ADDENDUM # 2

Project	Holy Family Catholic Elementary School	Project No.	2325
Location	1420 Grosvenor Street, Oakville, ON	Date of Issue	2024 04 05
Owner	Halton Catholic District School Board	File	2325/7.1.3

This Addendum forms part of the Contract Documents and amends the original Drawings and Specifications, dated 2024 03 26, and all preceding Addenda, as noted below.

ADDENDUM 01

1 NEW ROOF PLAN
A100 1:200

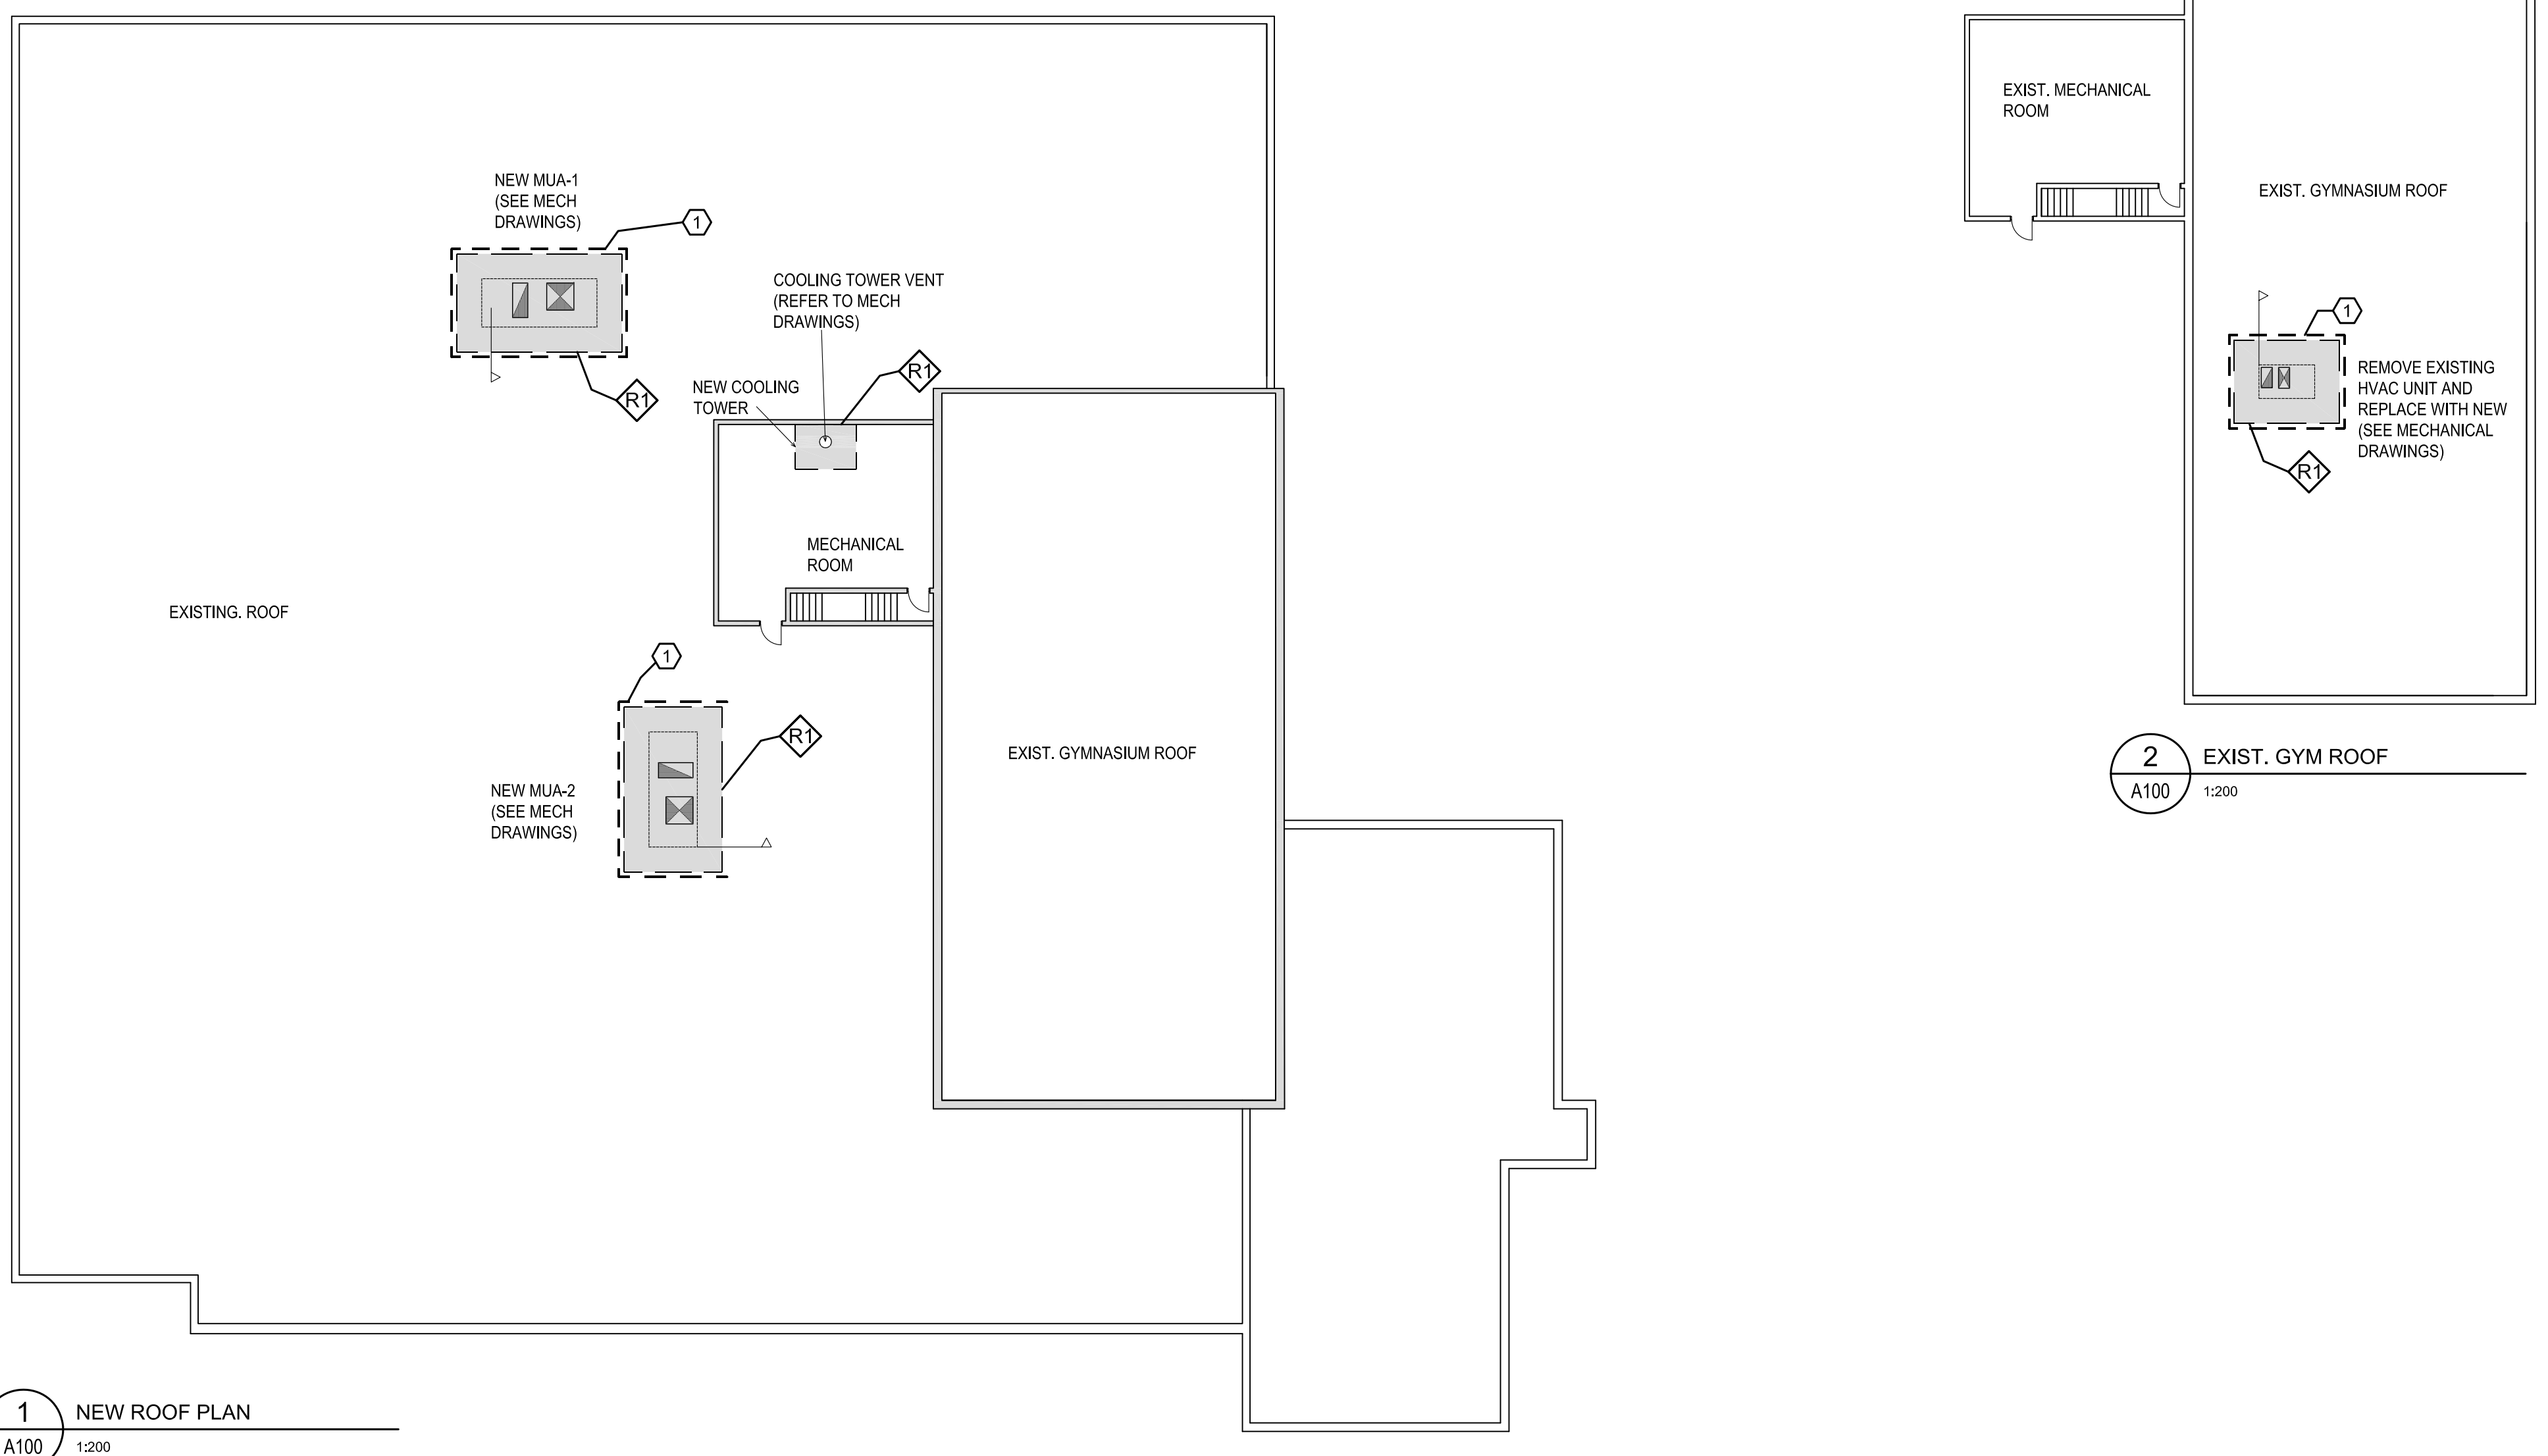
- 1 Drawing reissued as A100 Roof Plan & Details.

1 FLOOR PLAN - DEMOLITION PLAN
A100-D 1:200

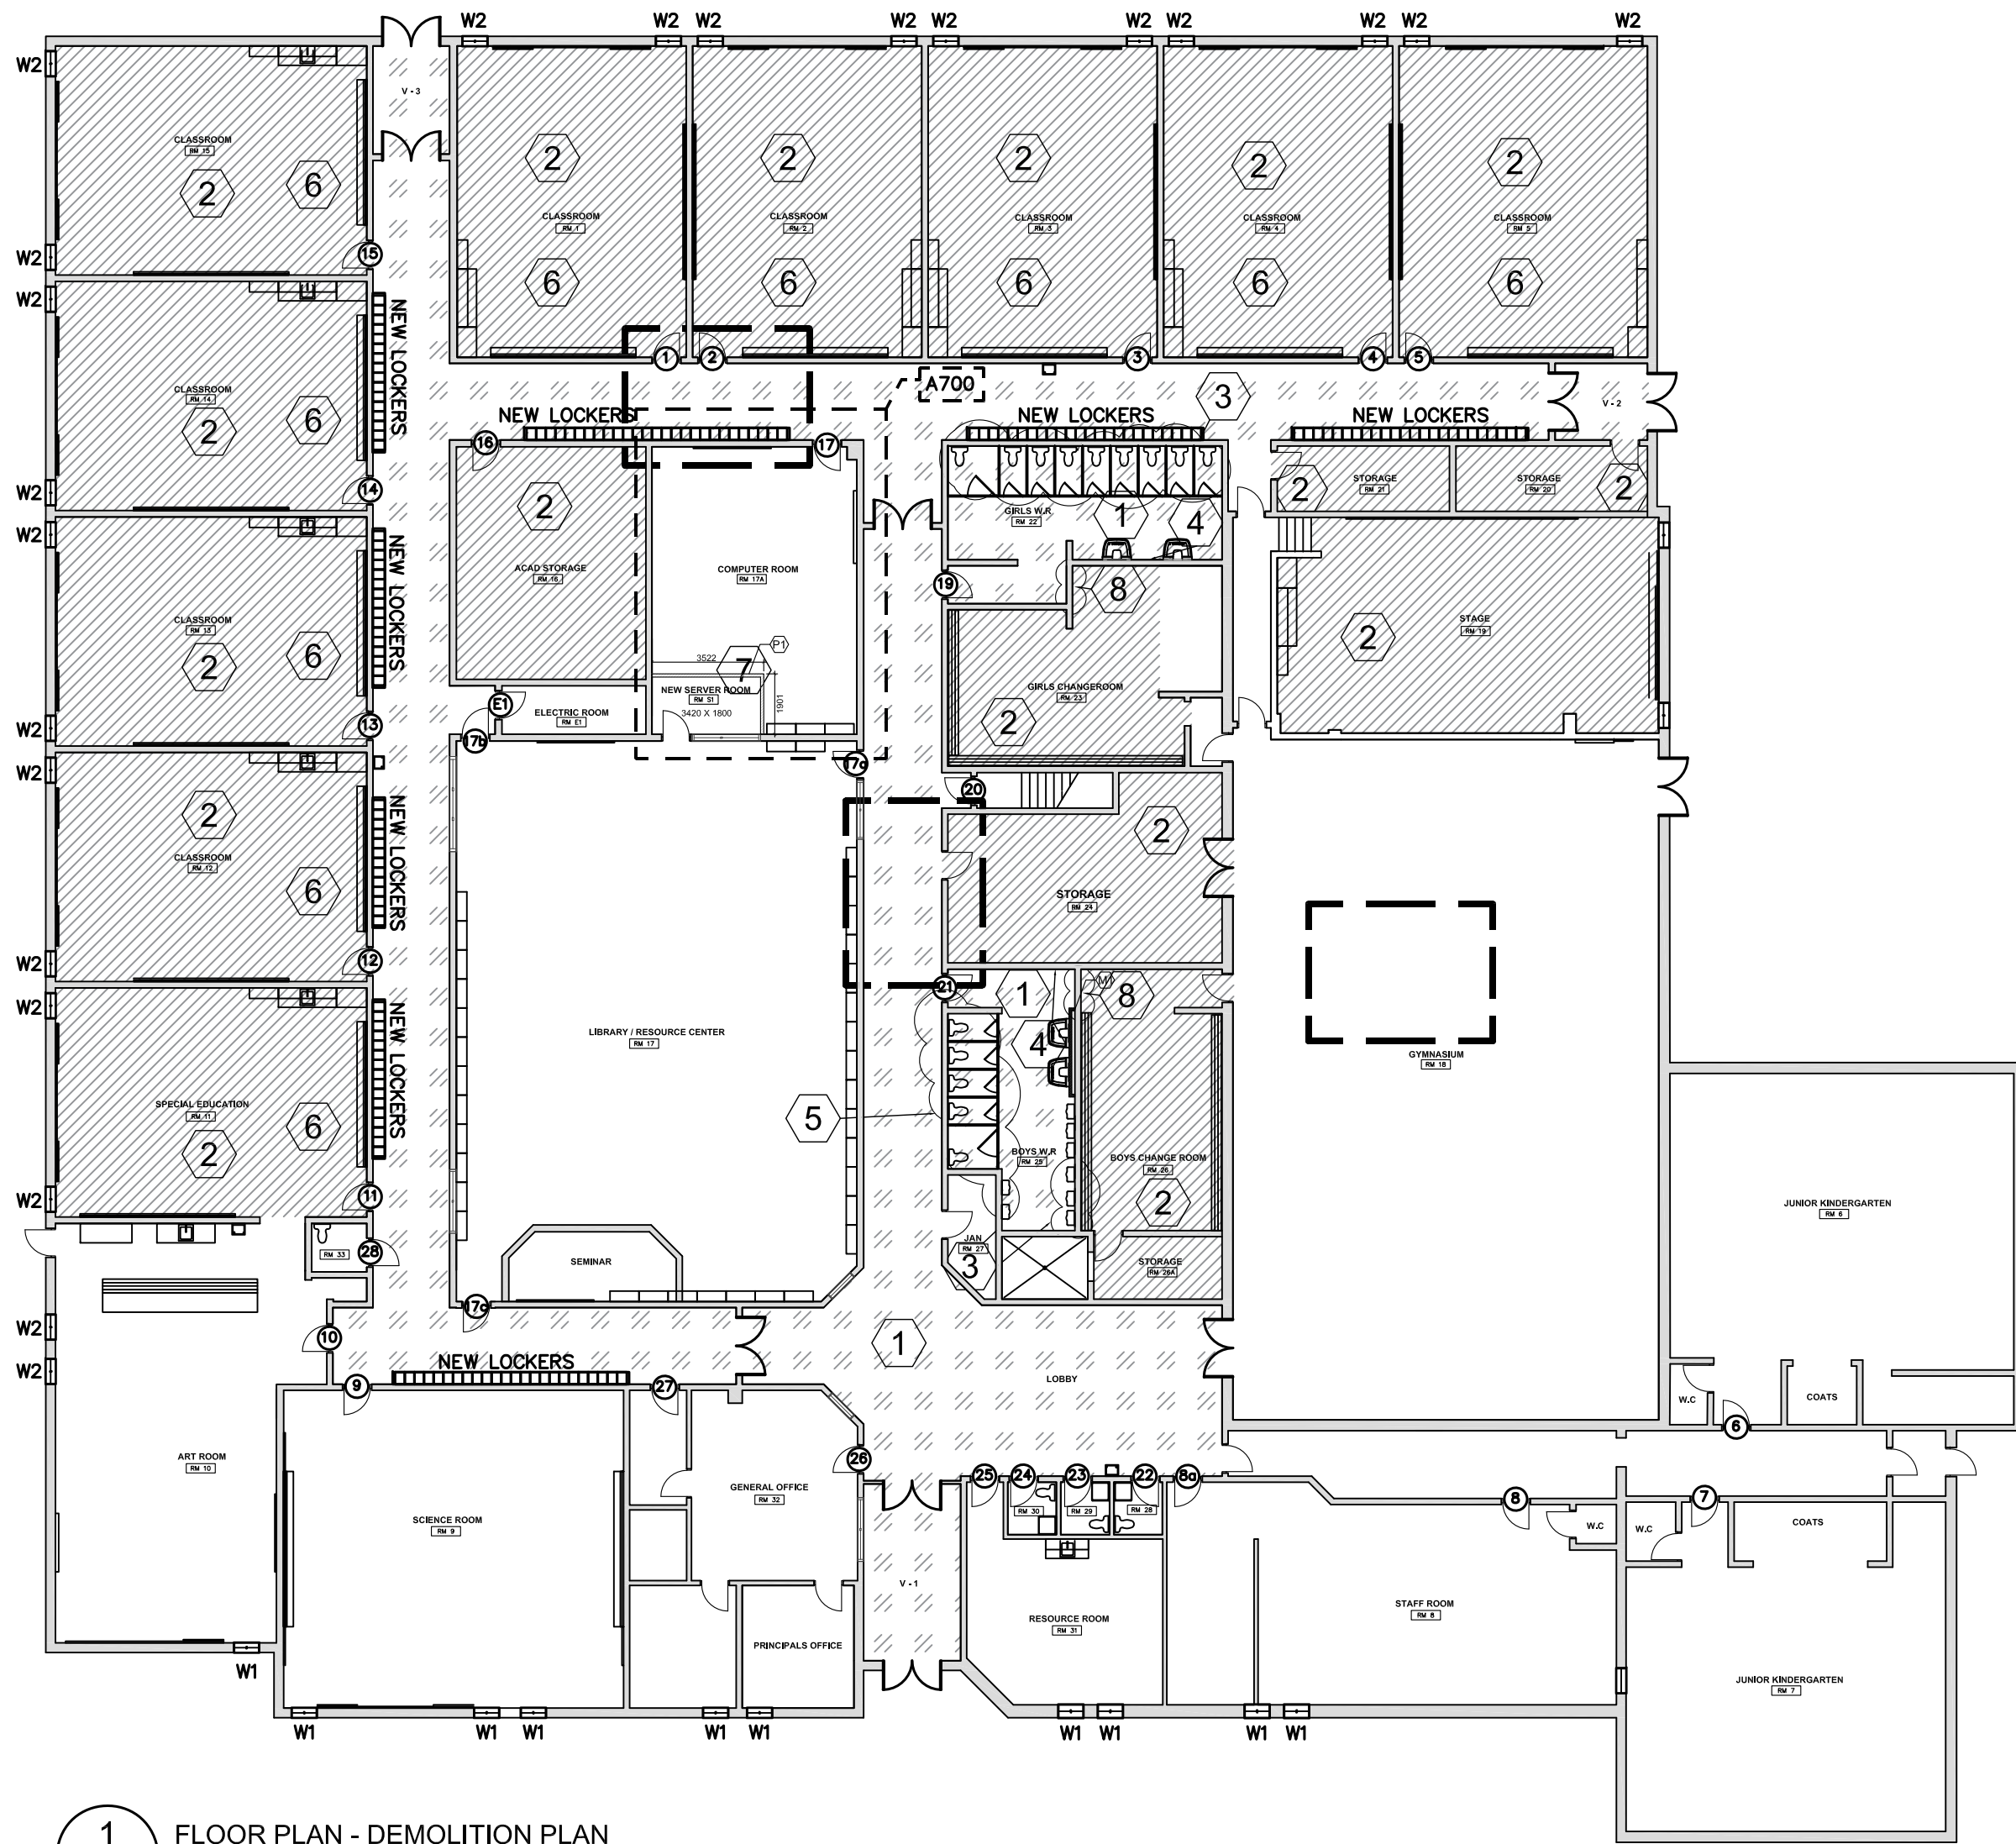
- 1 Replace drawing with attached Revision No. 1.
- 2 Drawing Reissued with additional Demo notes.

15 Q: Could you show the doors to be removed & disposed as part of the demolition?

A: Yes, refer to attached new Demolition Plan – Phase -1.

FIRST FLOOR PART PLAN 'C' - PLUMBING & DRAINAGE DEMO - PHASE 1

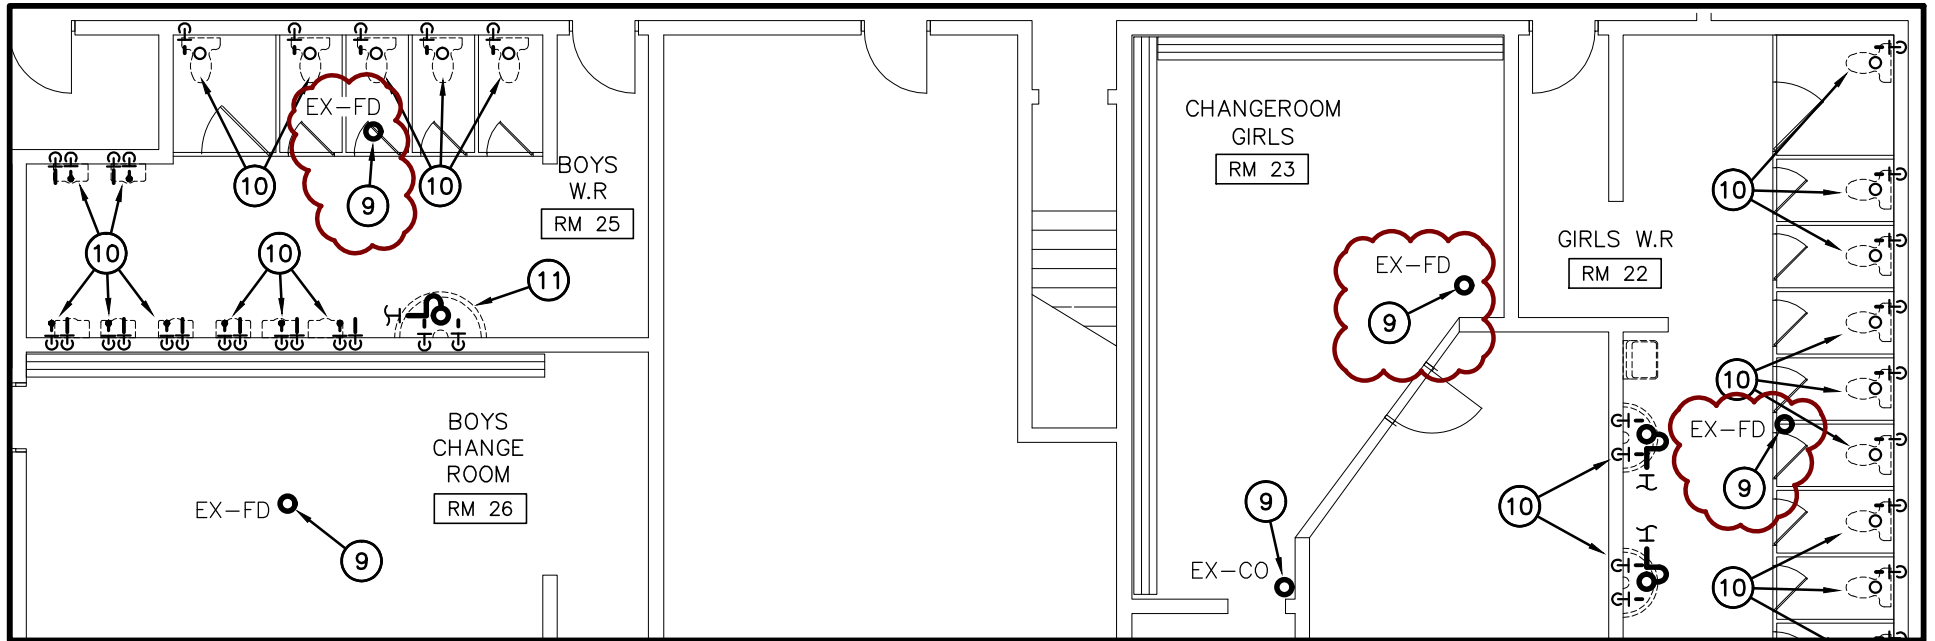
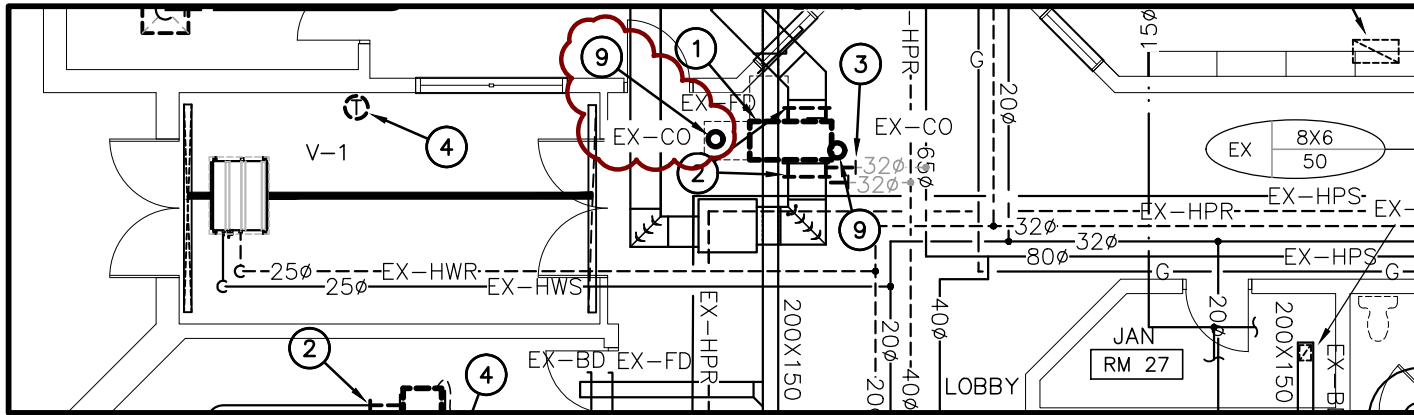
- 1.0 Reference Drawing M2.1 and Attached Sketch AD01-M01
- .1 In Boys' Washroom 25, Girls' Changeroom 23, and Girls' Washroom 22, floor drains to be removed completely in preparation for replacement, as per attached sketch AD01-M01.
 - .2 In lobby adjacent to Vestibule 1, cleanout to be removed completely in preparation for replacement, as per attached sketch AD01-M01.

FIRST FLOOR PART PLAN 'C' - PLUMBING & DRAINAGE RENO - PHASE 1

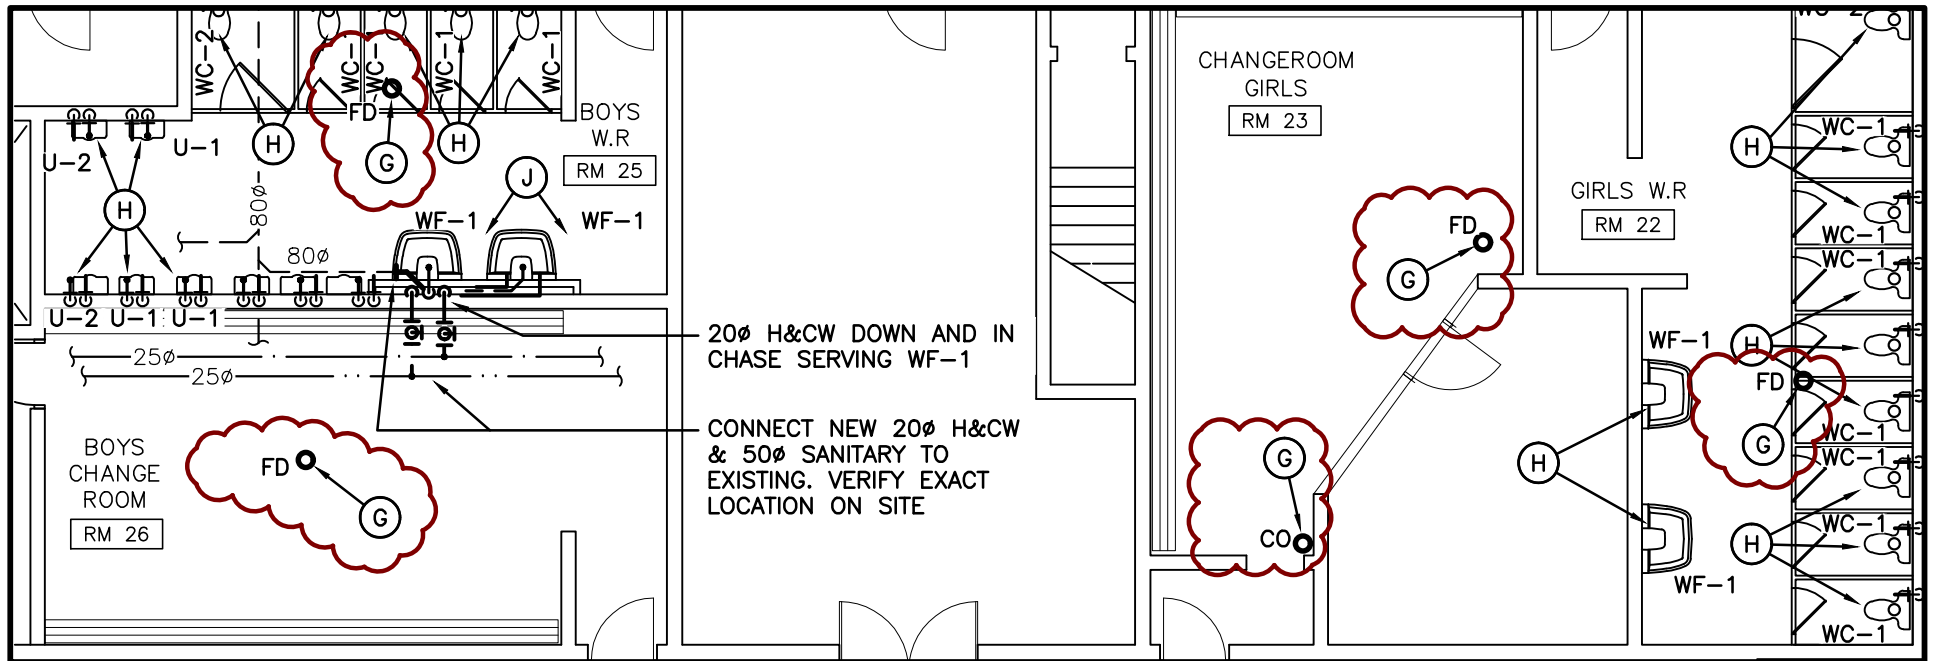
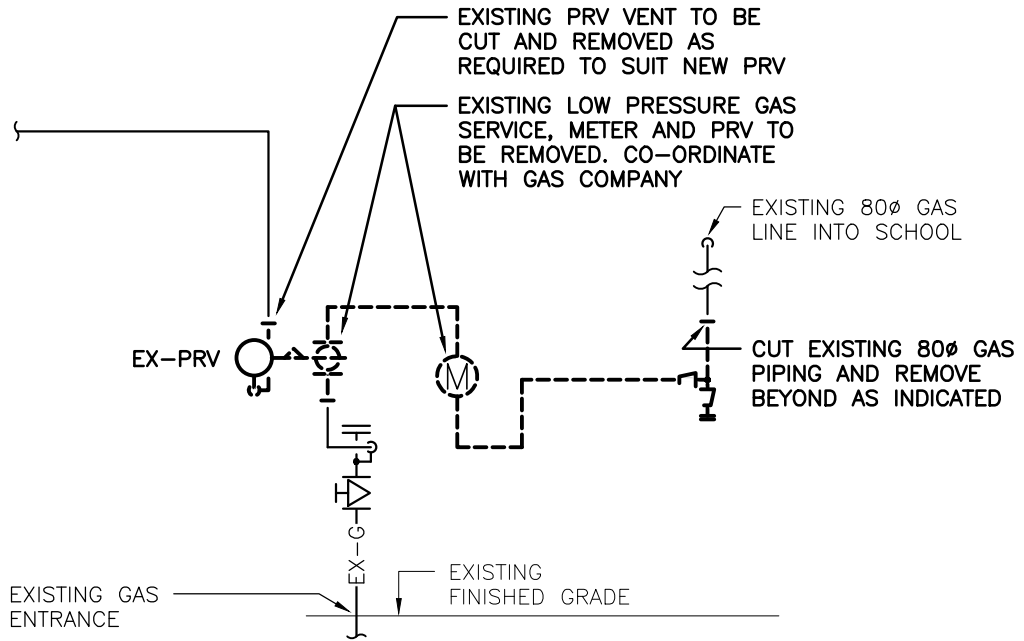
- 2.0 Reference Drawing M2.2 and Attached Sketch AD01-M02
- .1 In Boys' Washroom 25, Boys' Changeroom 26, Girls' Changeroom 23, and Girls' Washroom 22, add floor drains and cleanouts as per attached sketch AD01-M02.
 - .2 In lobby adjacent to Vestibule 1, add cleanout as per attached sketch AD01-M02.
 - .3 In 'Specific Renovation Notes', revise Note G to read as follows "INSTALL NEW REPLACEMENT FLOOR CLEANOUT/FLOOR DRAIN".
